ALERT SERVICE BULLETIN

206L-19-181

MODEL AFFECTED: 206L, 206L-1, 206L-3 and 206L-4

SUBJECT: TAIL ROTOR DRIVESHAFT DISC PACK
COUPLING NUTS, REPLACEMENT OF

Figure 1 - Typical Tail Rotor Driveshaft Disc Pack Coupling Attachments

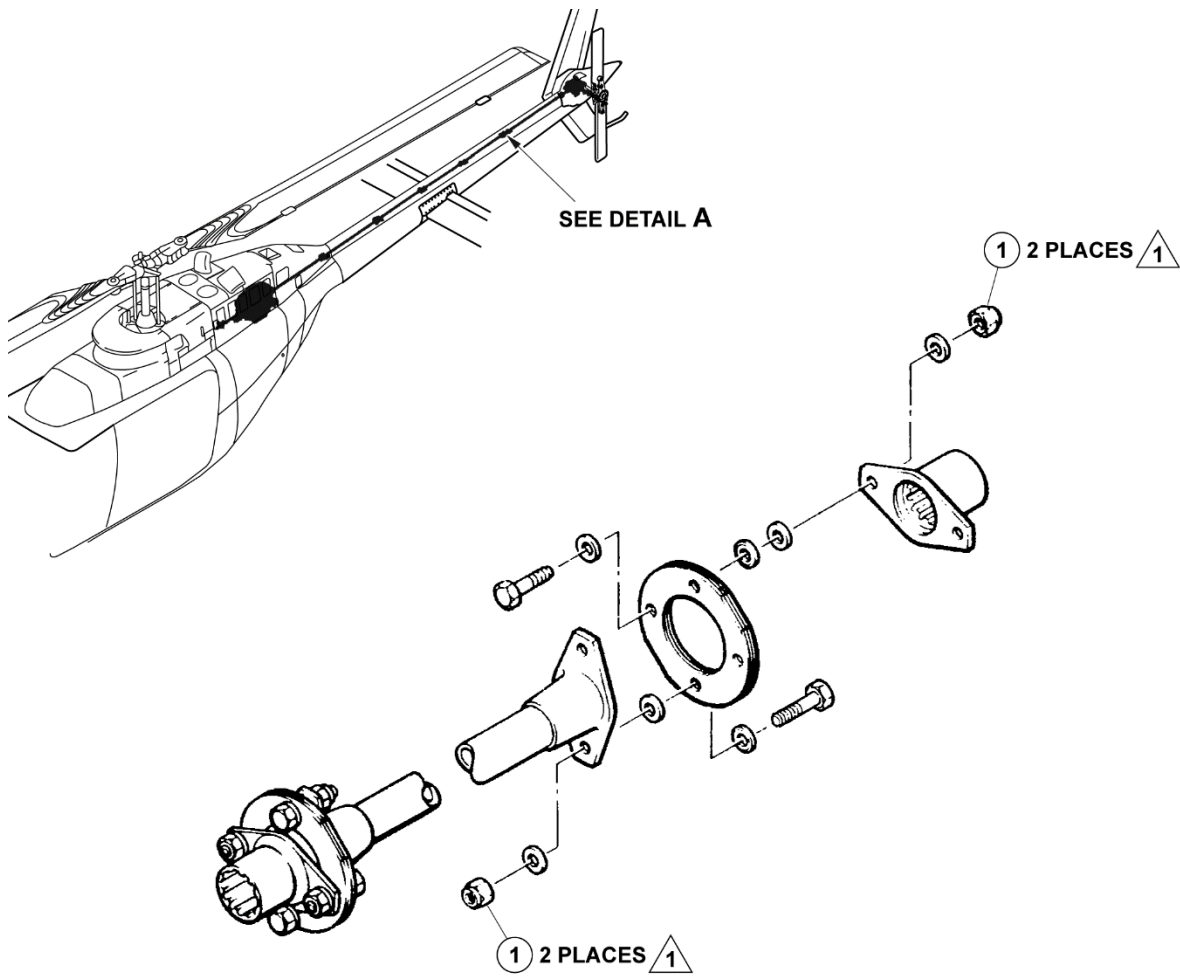
This Alert Service Bulletin (ASB) mandates the replacement of the MS21042L4 nuts with the 12-point NAS9926-4L corrosion resistant steel nuts.

2. Remove and replace the MS21042L4 nuts at each tail rotor driveshaft disc pack coupling with the 12-point NAS9926-4L nuts (refer to applicable 206L Maintenance Manual, Chapter 65). There are four (4) nuts at each disc pack coupling attachment (Figure 1).
3. After torquing nuts, apply a torque stripe (witness mark) to each nut using the torque seal lacquer (C-049), or equivalent (Figure 2). Application of the torque seal lacquer (C-049) is used to mark the nuts that have been torqued to visually identify movement of the nuts. Torque seal is brittle and will crack if the fastener moves.
4. If any MS21042L4 nuts are found loose or damaged, report at which location and provide the information to Product Support Engineering at productsupport@bellflight.com

- 1. Nut (NAS9926-4L) 4 Reqd.

- 1 Thirty-six (36) nuts required for the 206L (S/N 45004 through 45153 and 46601 through 46617), 206L-1 (S/N 45154 through 45790), and 206L-3 (S/N through 51612).
- 2 Twenty-eight (28) nuts required for the 206L-4 (S/N 52001 through 52492) and for 206L-1 or 206L-3 helicopters having Service Instruction BHT-206-SI-2052 (Increased Gross Weight Kit) incorporated.
